FORD AX4N

METALLIC "CLUNK" NOISE **DURING REVERSE ENGAGEMENT**

Figure 1
AUTOMATIC TRANSMISSION SERVICE GROUP

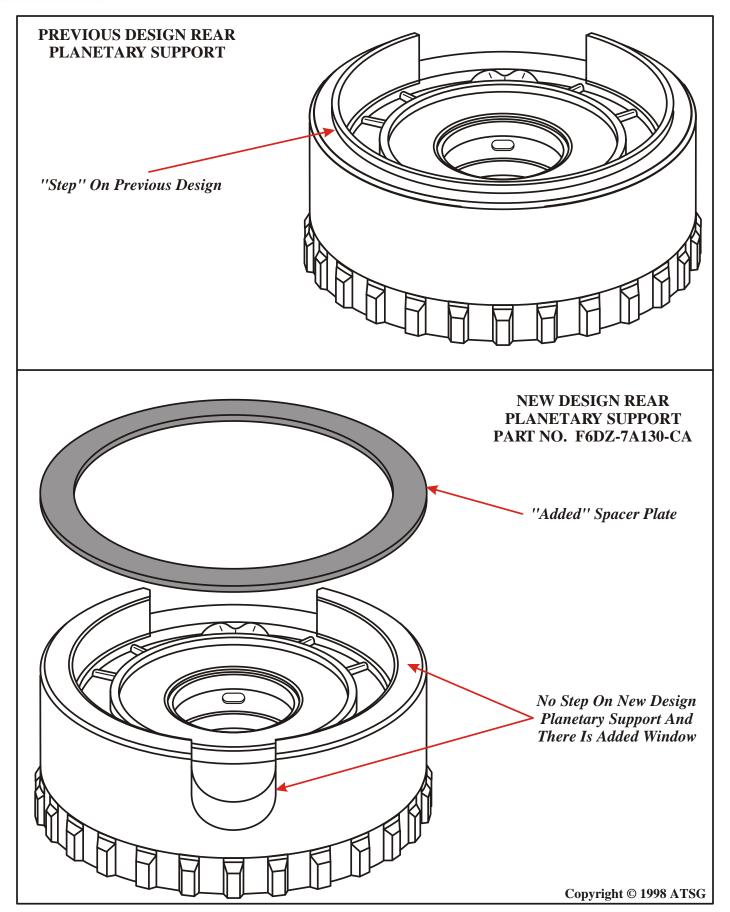
COMPLAINT: Some models of the 1994-1996 Taurus/Sable and 1995-1996 Continental, equipped with the AX4N transaxle may exhibit a metallic clunk noise coming from the transaxle during engagement to reverse. Upon inspection you will usually find that the lip on the previous design rear planetary support is damaged due to contact with the final drive ring gear and there may also be damage to the number 16 thrust washer on top of the return spring assembly for low/intermediate clutch pack.

The cause may be, the final drive ring gear contacting the internal case surface during reverse engagement.

CORRECTION: There is now available from Ford Motor Company a new design Rear Planetary Support, under OEM Part Number F6DZ-7A130-A, with the "Lip" removed and an added spacer that should reduce the possibility of final drive ring gear to case contact during reverse engagement. Refer to Figure 1 for illustrations of the previous and new design rear planetary supports. If it is necessary to replace the number 16 thrust washer, you must purchase service package part number F5DZ-7H266-A that includes the return spring assembly for the low/intermediate clutch. It is not available individually (See Figure 2).
